Conceptual Review Agenda

Schedule for 08/22/16 to 08/22/16

Monday, August 22, 2016

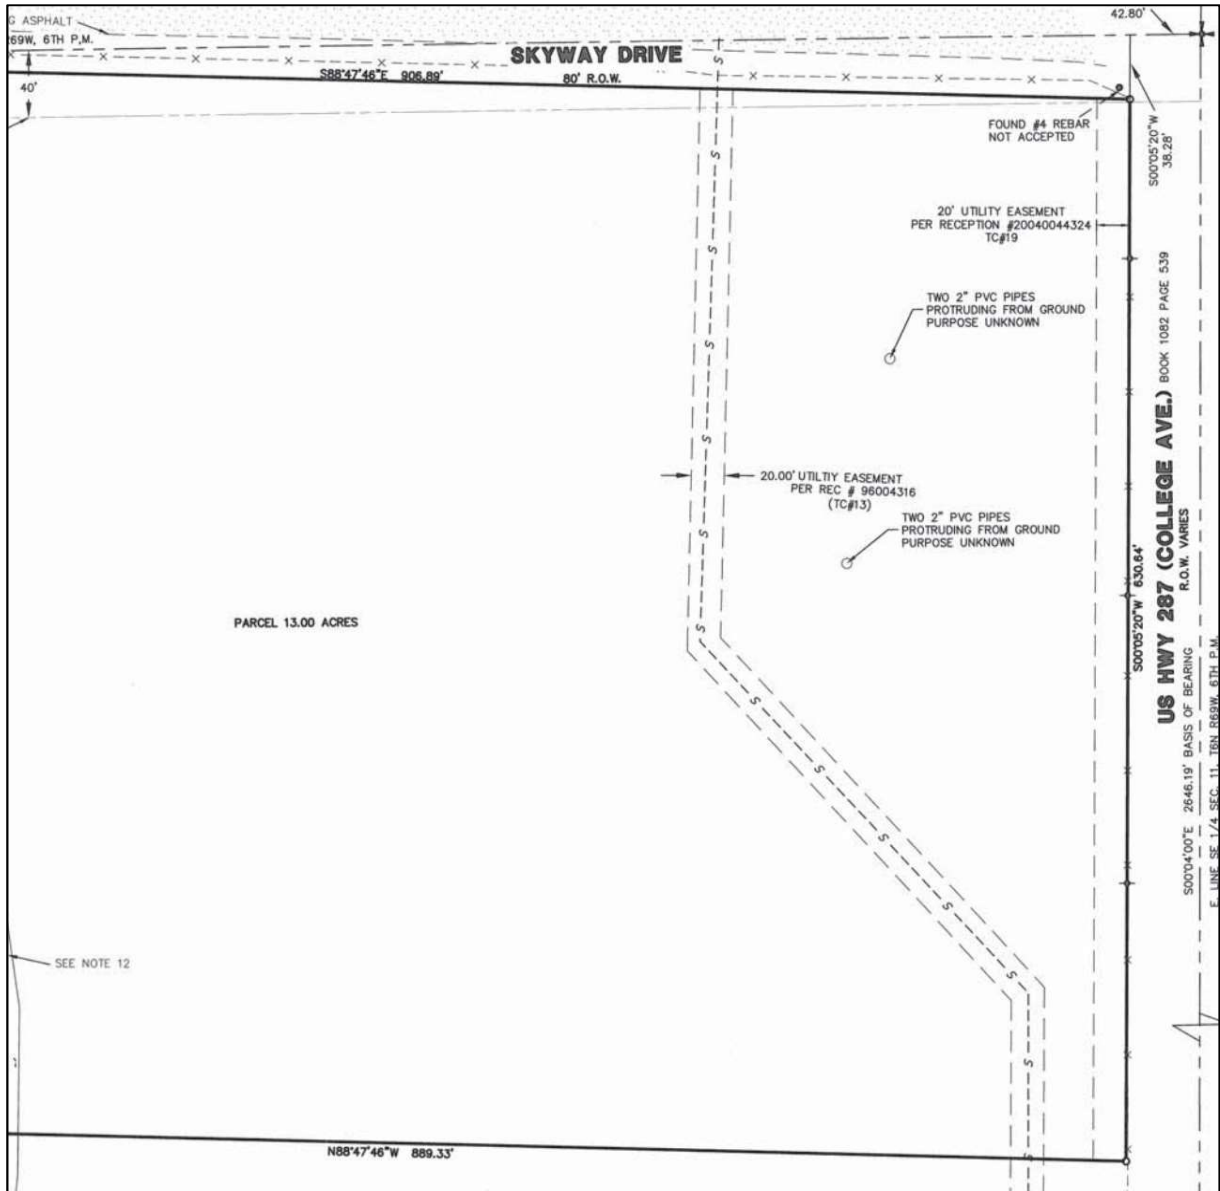
Dead-end roads over 660' require a second point of access. The proposed plan appears to create several dead-end conditions greater than 660' in length without a secondary access point. Code language provided below.

1. General Commercial zoning with Type II review for enclosed mini-storage, multi-family residential with less than 50 DU's Type I, greater than 50 DU's Type II. In combination of uses this will be a Type II.
2. Access off of Skyway is planned for primary entry point, but will need to coordinate with PFA for secondary emergency access.

3. Are there plans to connect a drive or street to the west and existing development?
4. Multi-family buildings - need to be oriented and face the public street and or Street-like private drive with front door entrances. the units can have access from both sides.

MASTERPLAN
 SITE PLAN

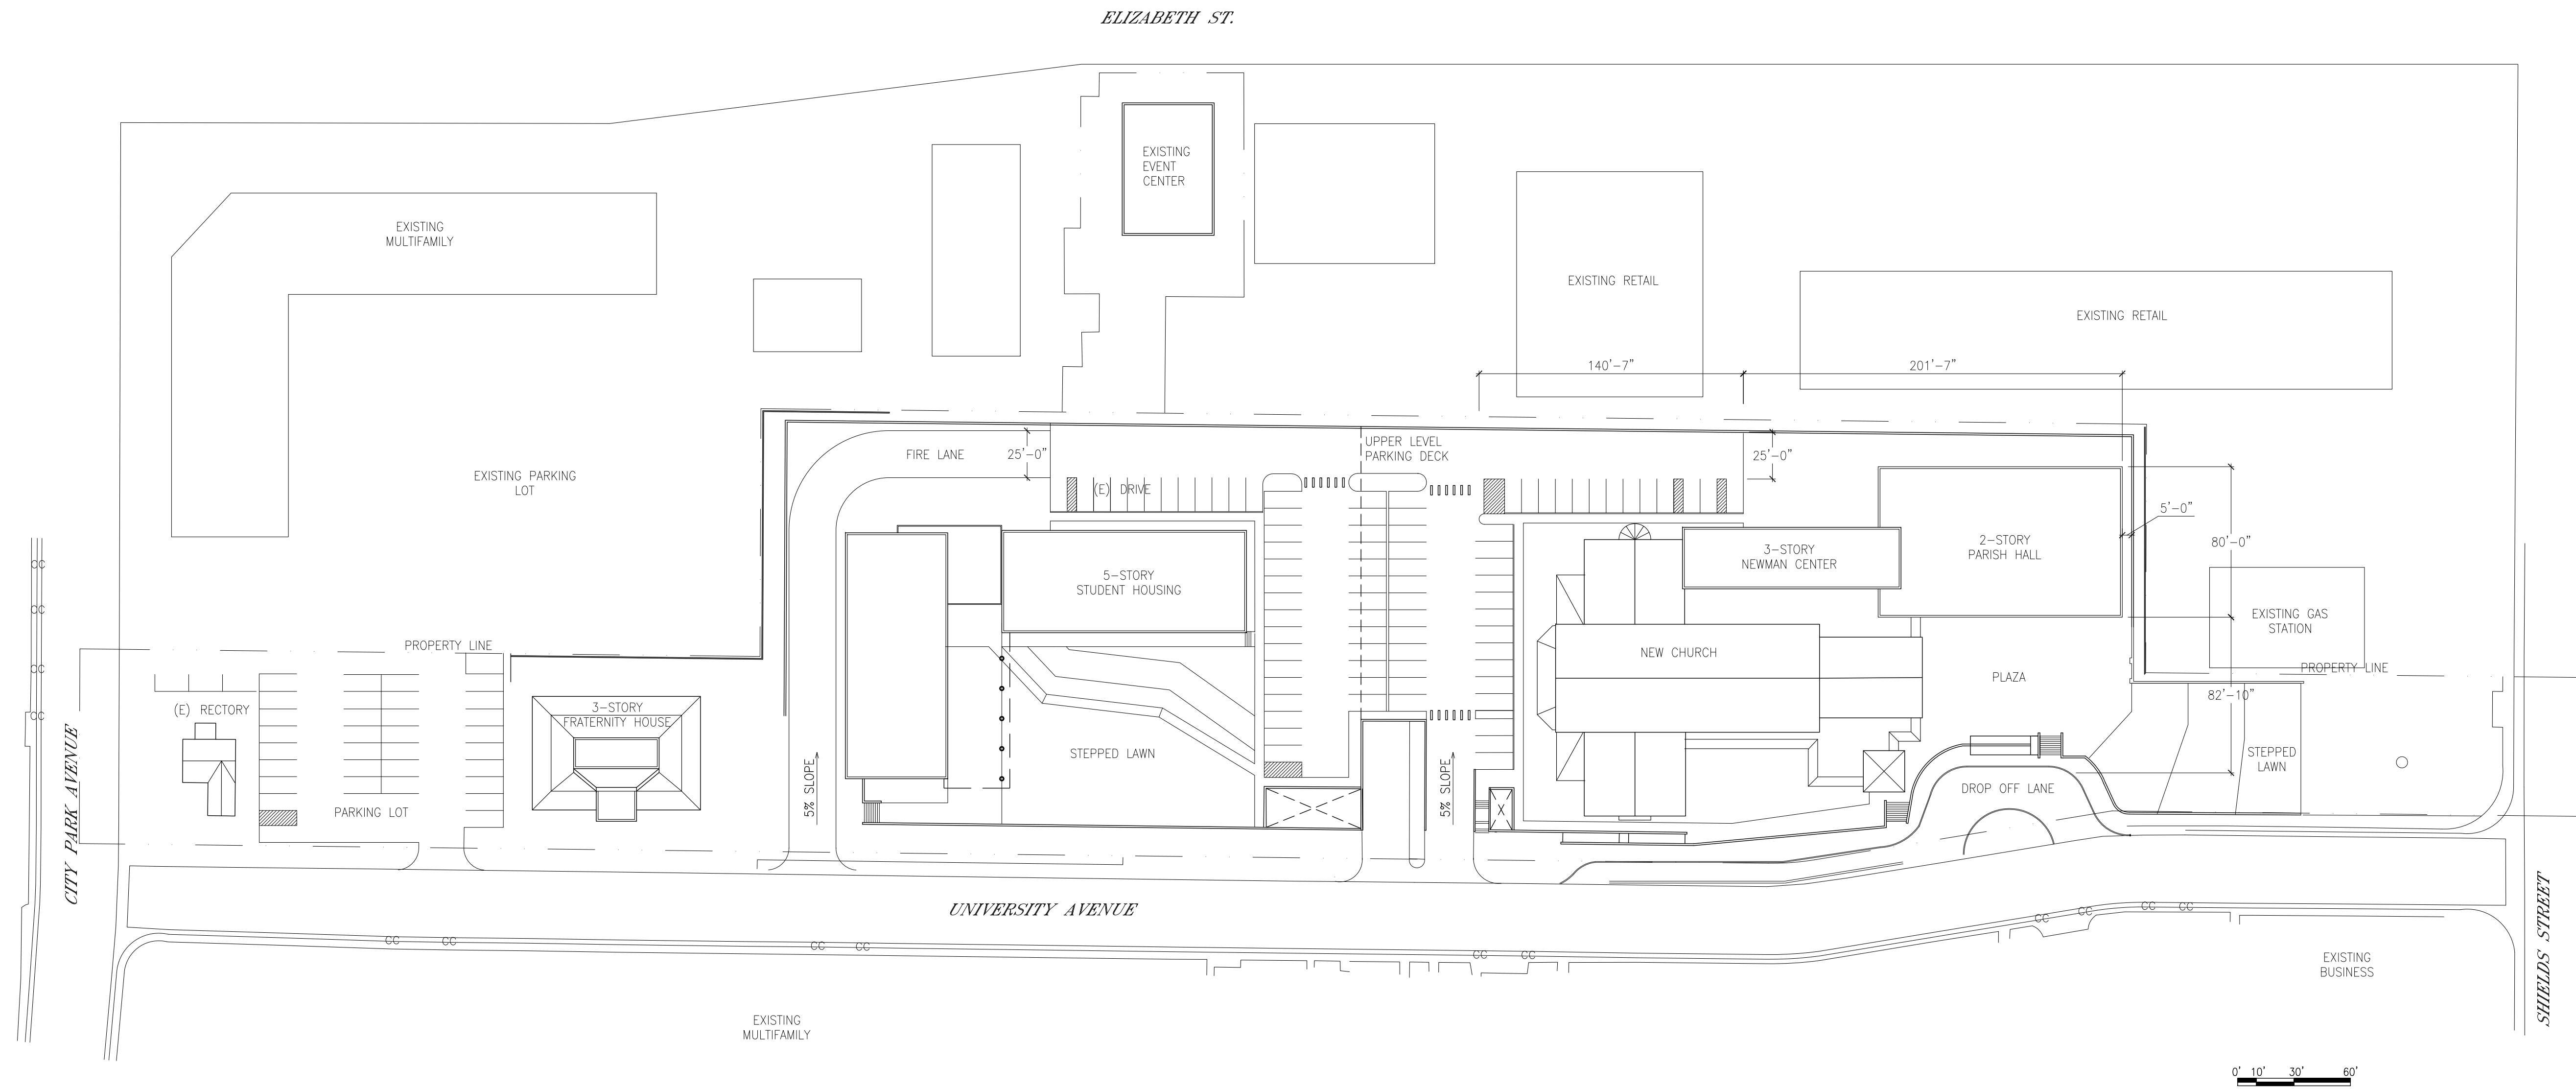
1. The anticipated traffic volume from this development meets the threshold for needing a Traffic Impact Study. Please have your traffic engineer contact me to scope the study. If this is planned to be built in phases we would likely want the traffic study to discuss the proposed phasing.
2. Although University is a local road consolidating accesses where possible and improving internal circulation is important.
3. Internal vehicular and ped/bike connections and flow seem a little awkward.
4. We will need to work with engineering to determine the appropriate frontage improvements along University including pedestrian amenities (detached walks?).
5. Ped connection between Campus West and this parcel needed if parking is shared. A pedestrian connection to University and Elizabeth is also needed.
